Serial: RNP-RA/06-0101

H. B. ROBINSON STEAM ELECTRIC PLANT, UNIT NO. 2  
DOCKET NO. 50-261/LICENSE NO. DPR-23

RESPONSE TO NRC REQUEST FOR  
ADDITIONAL INFORMATION REGARDING PROPOSED  
TECHNICAL SPECIFICATIONS CHANGE TO SECTION 3.5.2

### **RESPONSE TO NRC REQUEST FOR ADDITIONAL INFORMATION REGARDING PROPOSED TECHNICAL SPECIFICATIONS CHANGE TO SECTION 3.5.2**

Figure 1: Planned Strainer Configuration

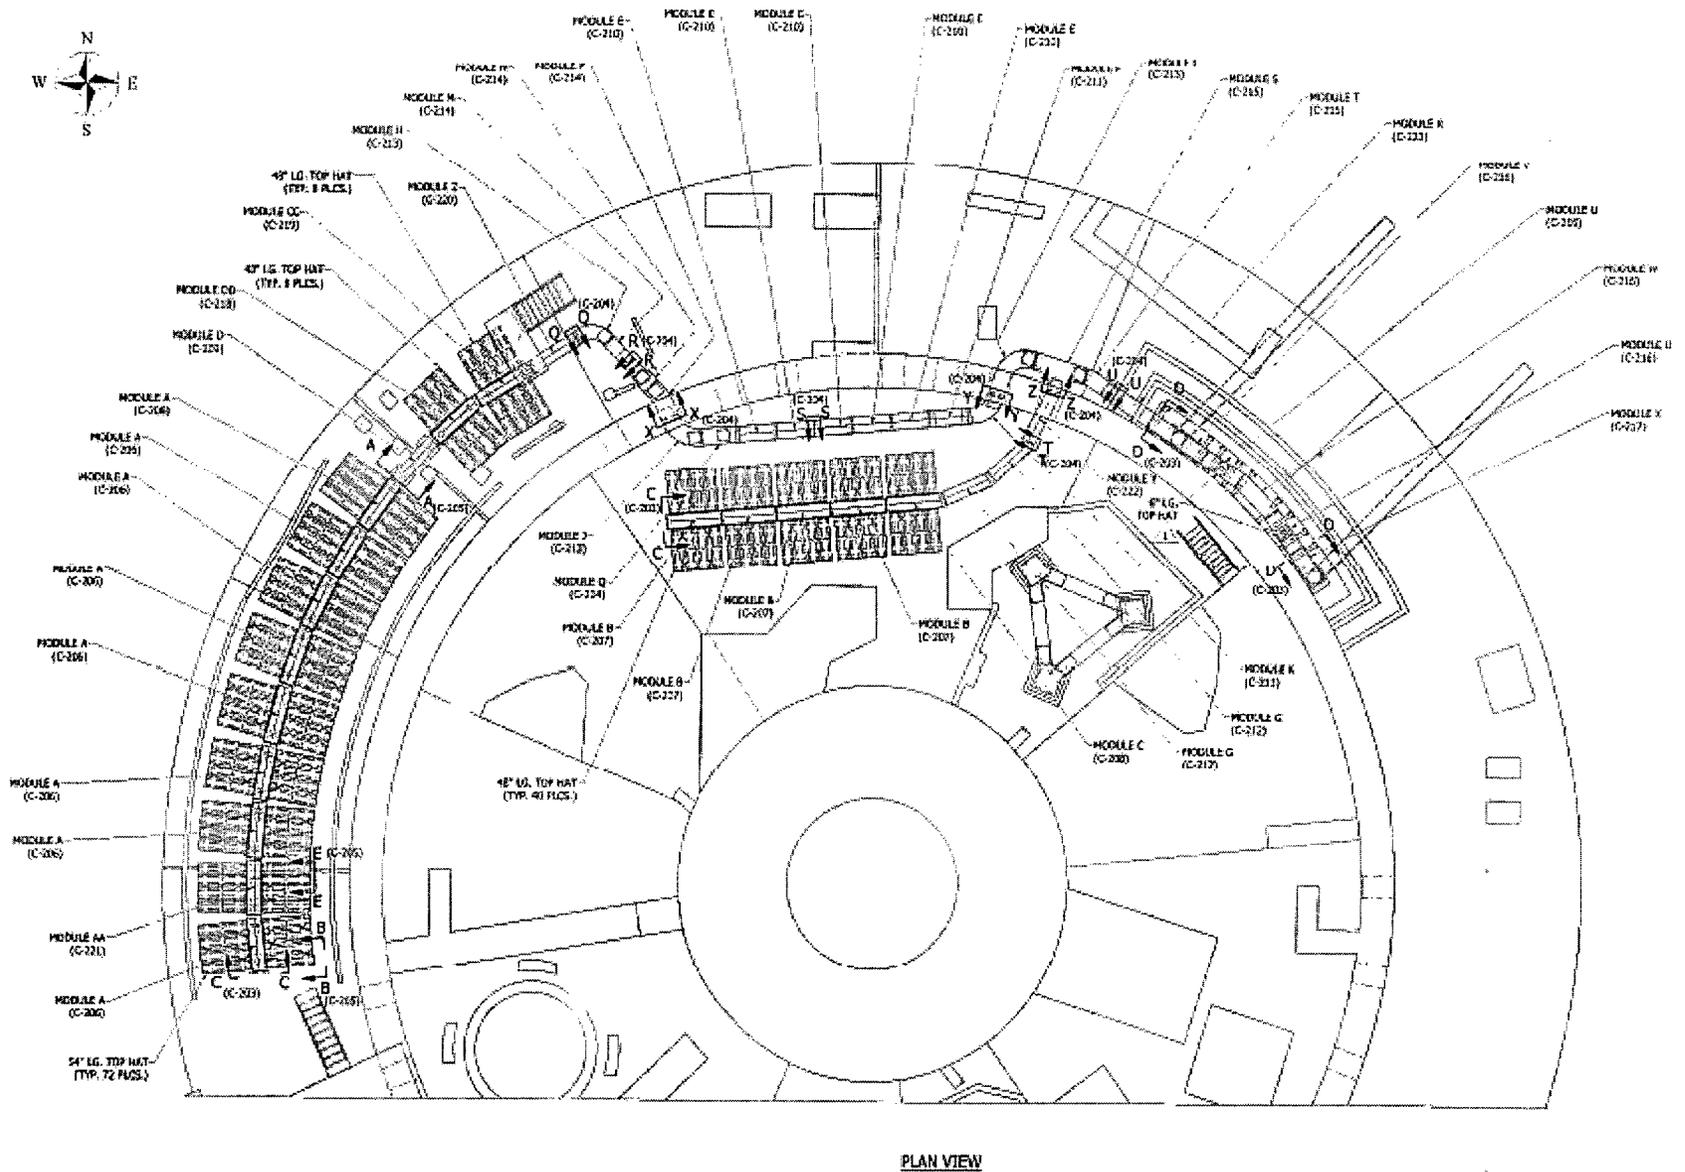
Identify the scope of the containment sump suction inlet periodic inspection required by Surveillance Requirement 3.5.2.6, including a list of the components and/or structures covered by the inspection for potential debris restrictions.

The scope of the containment sump suction inlet periodic inspection required by Surveillance Requirement (SR) 3.5.2.6, as proposed in the license amendment request dated June 1, 2006, is the containment sump suction inlet and the sump suction strainers. As shown in Figure 1 provided in this RAI response, the sump suction inlet and strainer is composed of a manifold with the strainer assemblies attached. Therefore, the scope of the proposed SR 3.5.2.6 inspection is the strainer and the strainer manifold.

Figure 2: Current Sump Configuration

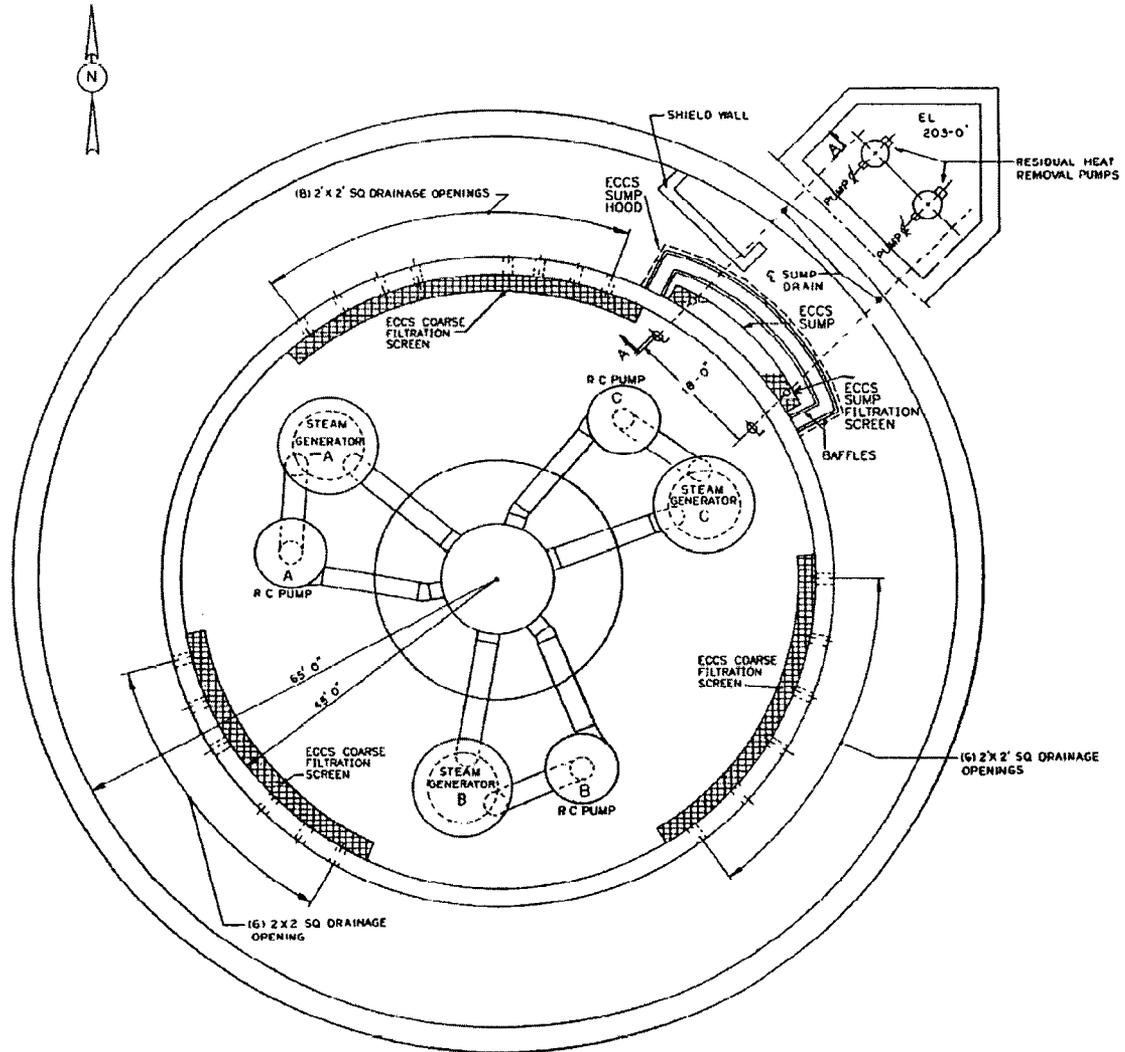
State whether the 1/2-inch mesh "prescreen" referred to in UFSAR Section 6.3.2.2.2 is the "trash rack" referred to in SR 3.5.2.6. If the "trash rack" referred to in SR 3.5.2.6 is a different component or structure, please provide a basic description of this component, including its surface area, mesh size, and location in containment.

The information in Section 6.3.2.2.2 of the UFSAR states, "Neutral and near neutral buoyant debris greater than 7/32" diameter are stopped by the sump screens. The screens consist of a prescreen with a 1/2" square mesh opening in series with a 7/32" square mesh opening screen. This prescreen reduces the debris loading on the final screen." The 1/2 inch square mesh screens are not considered to be trash racks. They are considered to be part of the screens at the sump inlet. The coarse screens at the base of the shield wall, described in response to NRC Request 2, are considered to be the trash racks. These trash racks are shown on Figure 2 and have an approximate 1 inch mesh size. The trash racks are mounted on an approximate 45 degree angle and have approximate dimensions of 4.24 feet wide by 141.4 feet long, which results in approximately 600 square feet of surface area.
